**Submission on publically notified proposal for policy statement or plan,
change or variation under Clause 6 of Schedule 1, Resource Management Act
1991**

Submission on: Proposed Private Plan Change 52 - Development Concept
Plan for Milk Processing Factory, SH26, Tatuani

Council's submission on Proposed Private Plan Change 52 - Development Concept Plan for Milk Processing Factory, SH26, Tatuani

Attachment 1

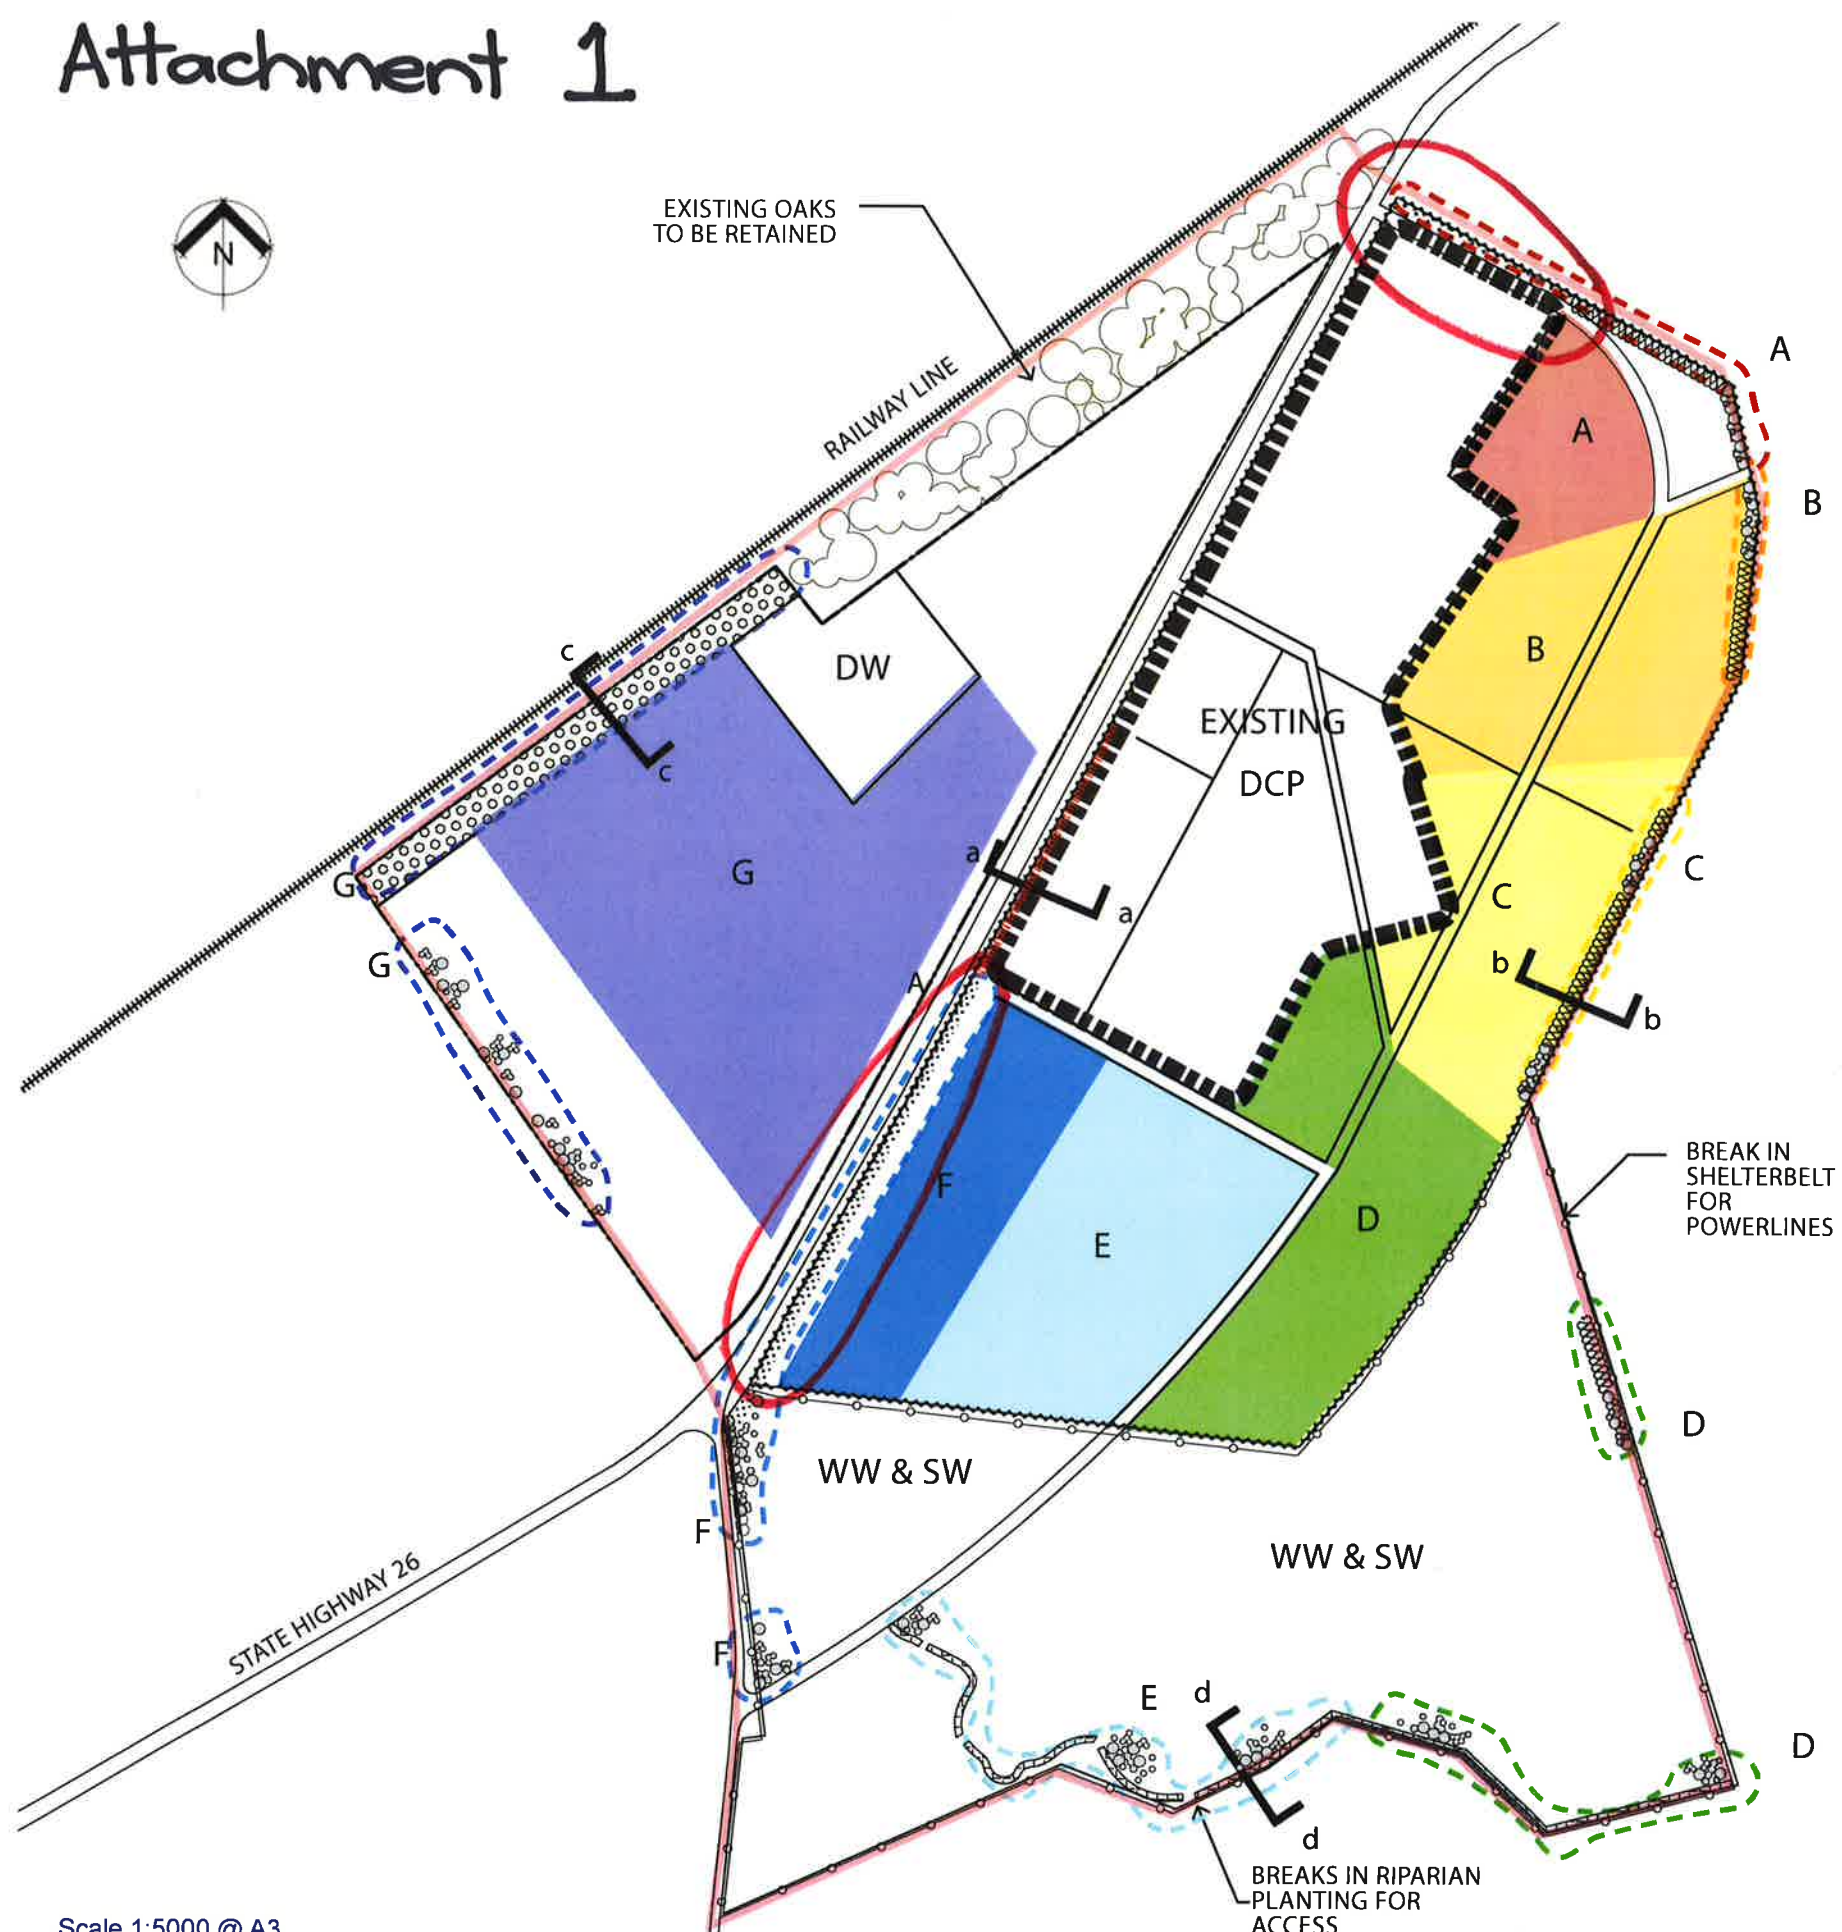
Sheet 7 Attachment B: Development Concept Plan – Planting Plan	Planting Area F on the key	The inclusion of Planting Area F on the key appears redundant due to the inclusion of Planting Area E/F. Building Area E is behind Building Area F, which is located beside State Highway 26. Therefore, the development of either Building Area E or F would require landscaping planting. The existing key entry for Planting Area E/F enables this.	Accept, with amendments	Remove "Planting Area F" from the key.

Sheet 7 Attachment B: Development Concept Plan – Planting Plan	Key	To ensure all features on the map are also referenced on the map's key. Remove reference to "Attachment B:" from the title of Sheet 7 as it will be a component part of the DCP and not an attachment.	Accept, with amendments	1) Include on the key the boundaries for Development Areas 1-3 which are shown on Sheet 7. 2) Include on the "Proposed Planting" key, the planting feature, resembling small crosses, within Planting Areas A and F. Please see Attachment 1 for details. 3) Remove reference to

"Attachment B:" from the title of Sheet 7.
Sheets 8, 9 and 10 Attachment C: Development Concept Plan – Planting Cross Sections		Remove reference to "Attachment C:" from the title of Sheets 8, 9 and 10 as they will be component parts of the DCP and not attachments.	Accept, with amendments	Remove reference to "Attachment C:" from the title of Sheets 8, 9 and 10.
